ADDENDUM NO. 4

**TO THE PLANS AND BID DOCUMENTS FOR THE
PHASE 1B STAGES 4 AND 5 LINER CONSTRUCTION PROJECT
at the VICTORVILLE SANITARY LANDFILL
in Victorville, California**

March 30, 2026

ATTACHMENT NO. 2

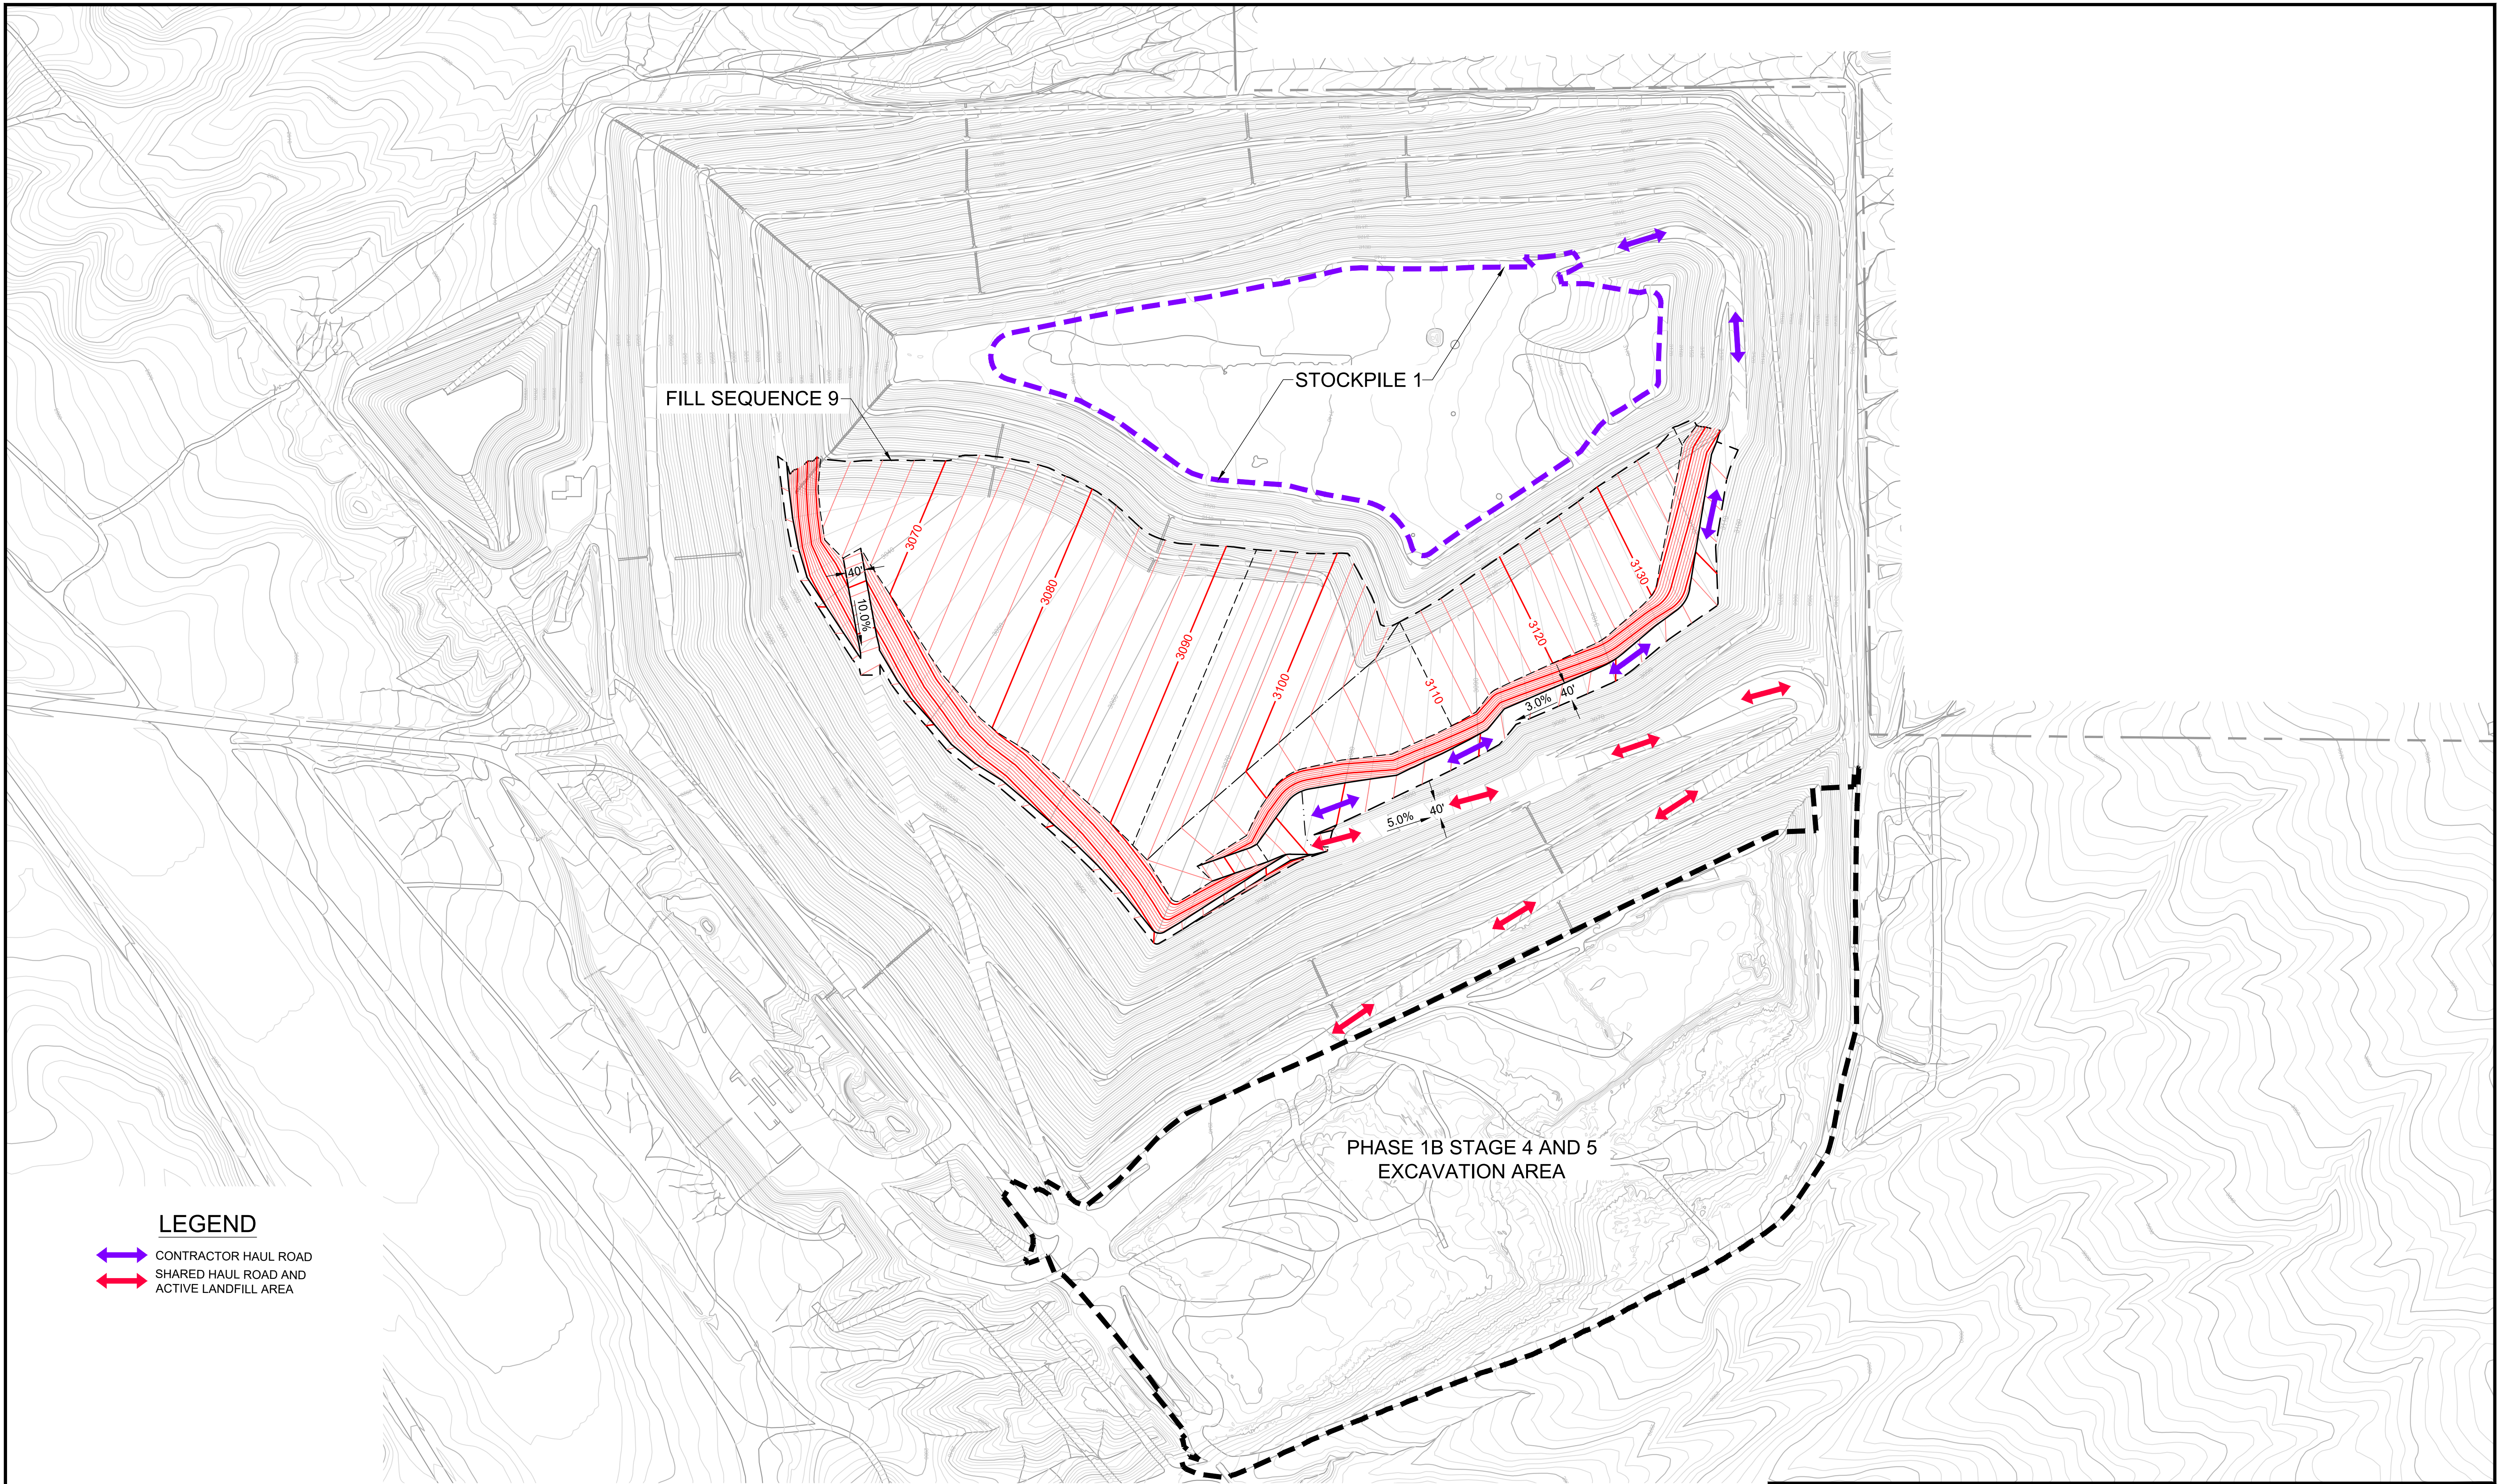
11. Based on discussions during the previous job walk, there was a mention of a new waste fill plan. We understand that current landfill waste operations have shifted in certain areas, which may impact proposed haul routes & construction logistics. Could the county confirm that the haul routes indicated on the plans will not change however if so would it be possible to receive the updated waste fill plan to plan our haul routes accordingly.

A11. Please see Attachment 2 included in this Addendum No. 4 showing the intended haul route with the anticipated fill plan for reference only. Refer to Sheet C9 of the Plans for all other construction notes and details.
